THE SOD GUY - SALES LOT

CONSTRUCTION DRAWINGS

LOT 1, APPALOOSA HIGHWAY 24 SUBDIVISION FILING NO. 1A

FA PROJECT NO. 04-18-0188
MAY 21, 2019

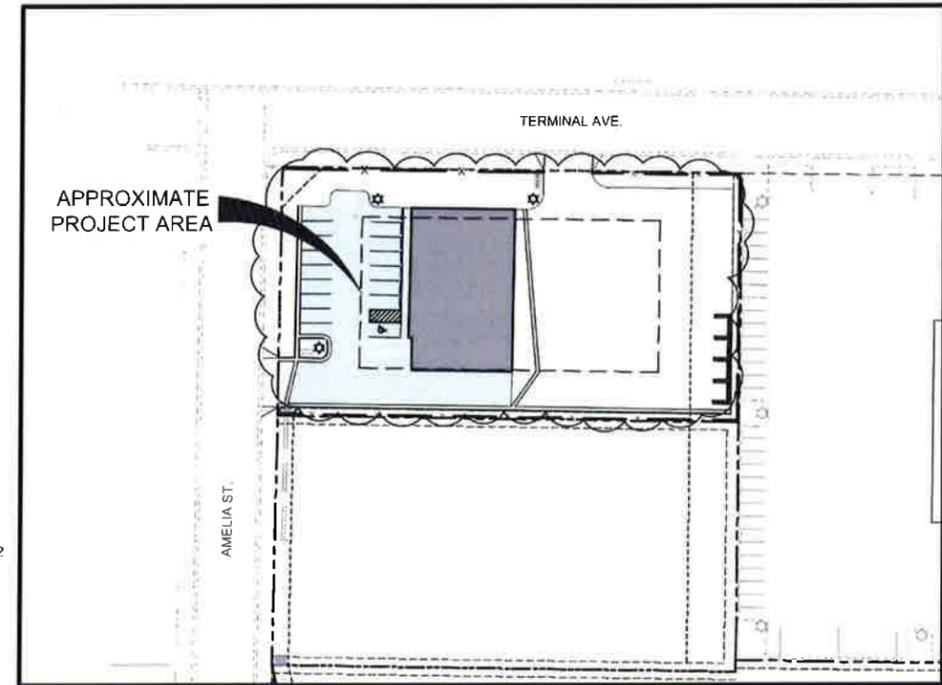
Add CRUD Signature Block
 JS 06/06/19

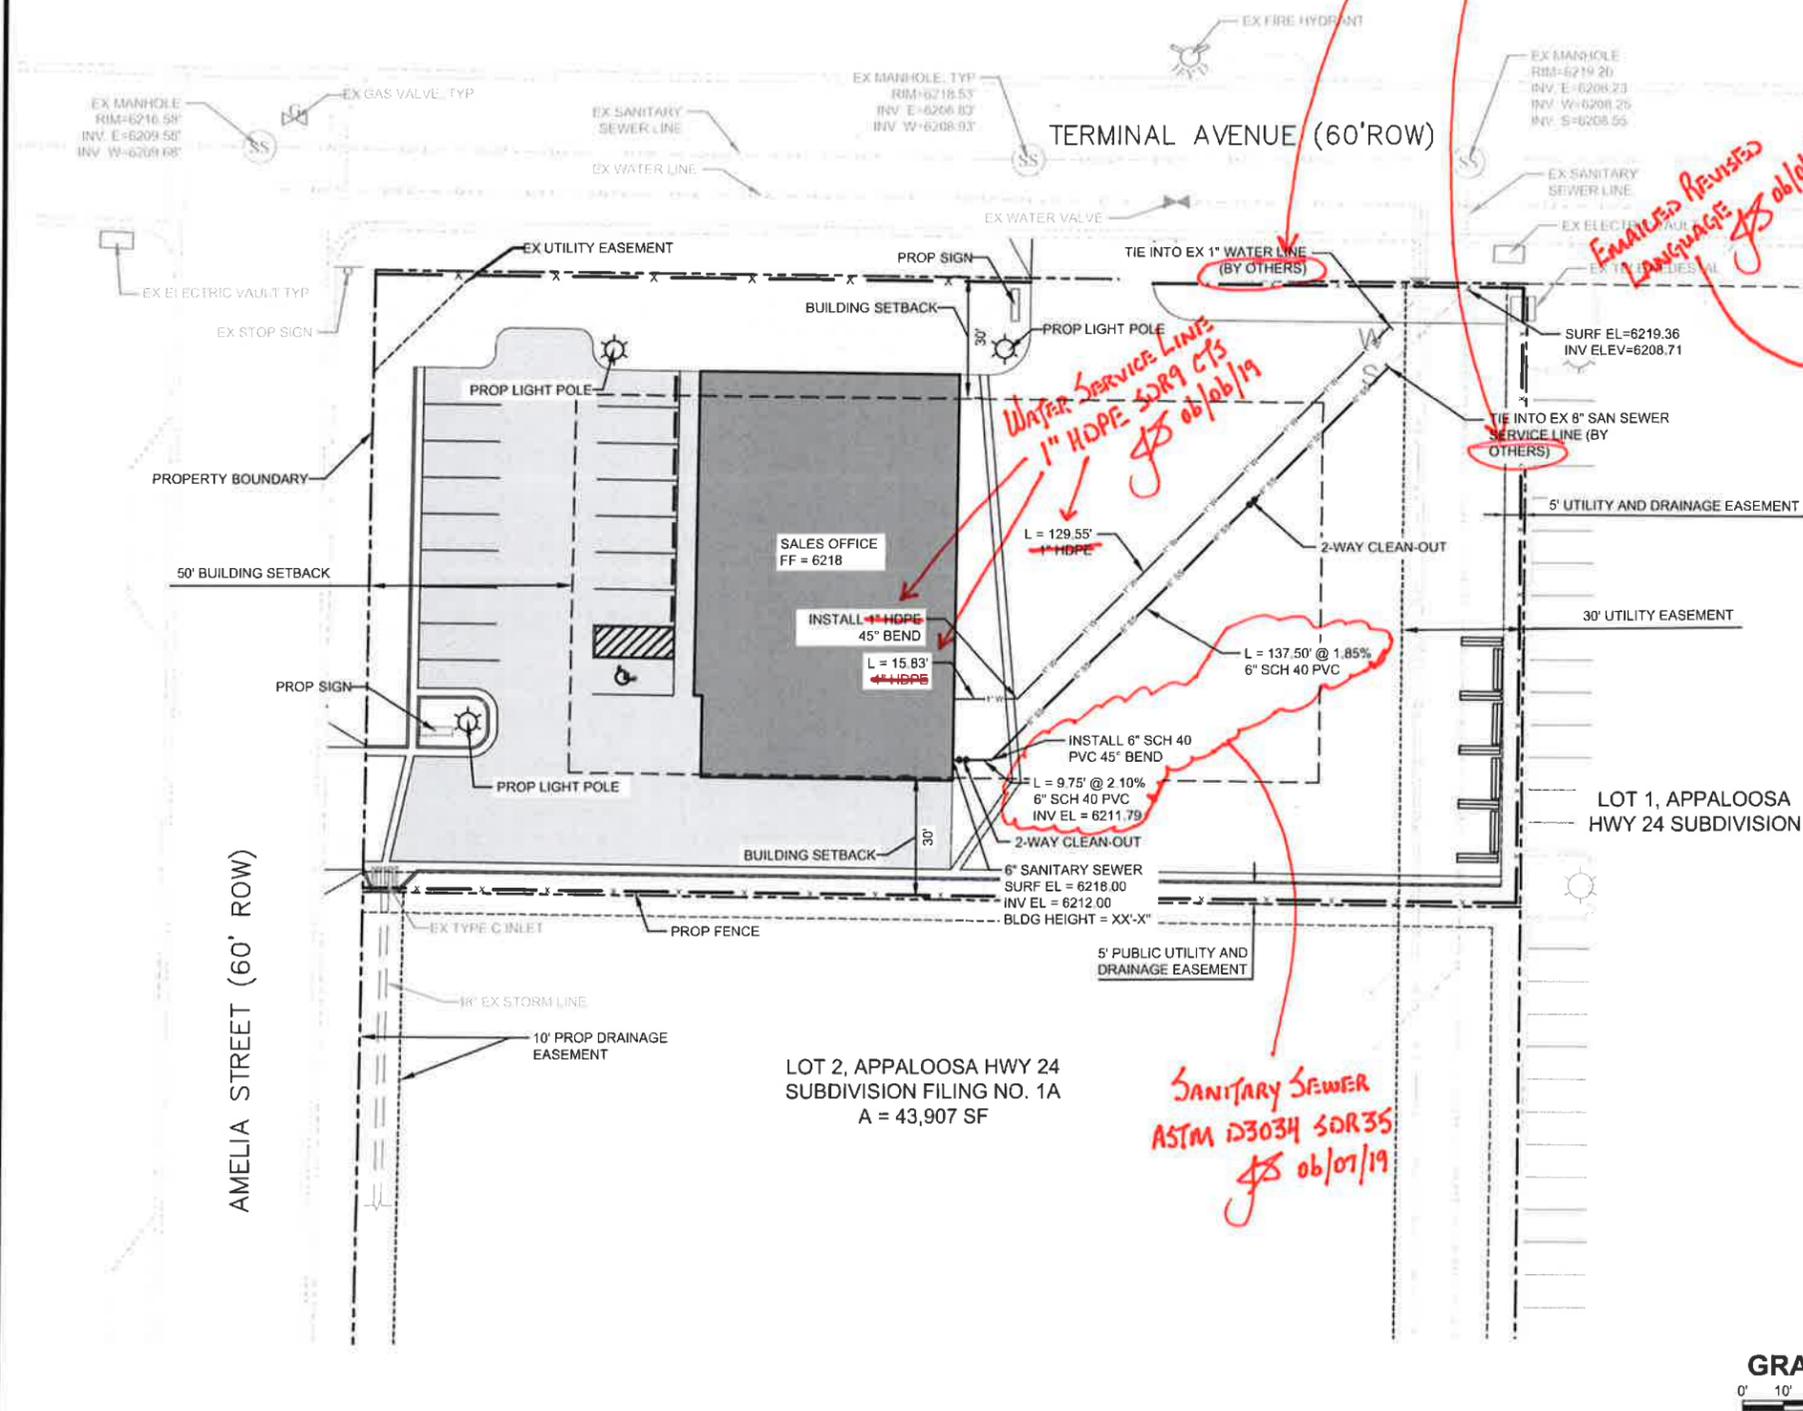
HOPE: SDR9 CTS
\$8 06/06/19

CMO Will Witness But Will Not Be Making These Connections
\$8 06/07/19

EMERGENCY REVISIONS LANGUAGE
\$8 06/06/19

Water Service Line
1" HOPE: SDR9 CTS
\$8 06/06/19

Note # 29
\$8 06/06/19

Sanitary Sewer
ASTM D3034 SDR35
\$8 06/07/19

SALES LOT - SPECIAL USE
SECTIONS & DETAILS

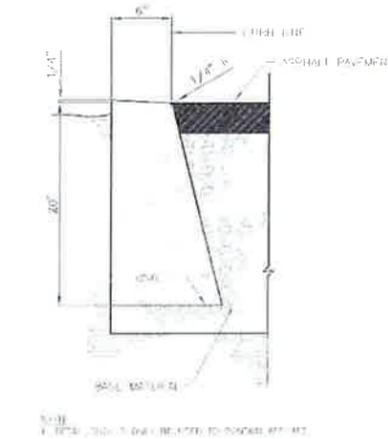
*Add CMD Detail WW-8B
JS 06/06/19*

*"TRACER WIRE"
Add CMD Detail W-12
JS 06/06/19*

*"MEETER SET DETAIL"
Add CMD Detail W-39
JS 06/06/19*
